## Modification to run CPU09CMI on 4MHz bus.

9001-11641000

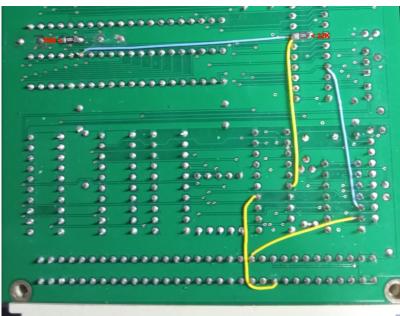
Now we need the Q clock on the 09FLP

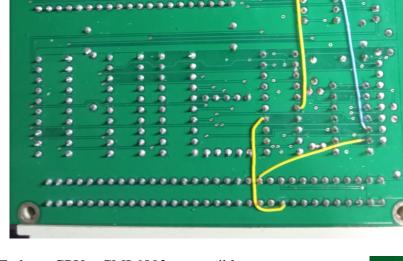
Replace xtal into 16MHz. Replace C1 and C2 by 15pF. Place 10M smd between crystal pins. Replace GAL CMI\_1 by CMI-4\_1 Only use the HD63C09.

## On top side:

Cut trace between U4-14 and J1 C-21 (B\_VMA) For REV:0.9 print only cut trace from J1 A23 to R15

## On solder side:

Cut trace between U13-19 and via (OVMA) Place 22K resistor between U13-19 and Gnd Place wire from U6-35 to U13-19 and U4-6 (O) Place wire from U4-14 to J1 A-23 (B\_Q)

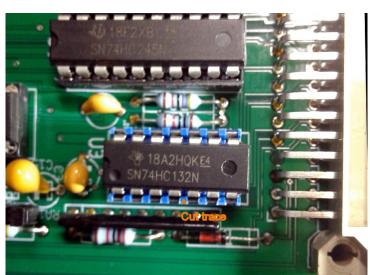
To keep CPUxxCMI 6802 compatible:

On top side:

Cut trace between U3-4 and U3-5

On solder side:

Place wire from U3-5 to U13-9 (VMA) Place wire from U3-6 to J1 C-21 (B\_VMA)
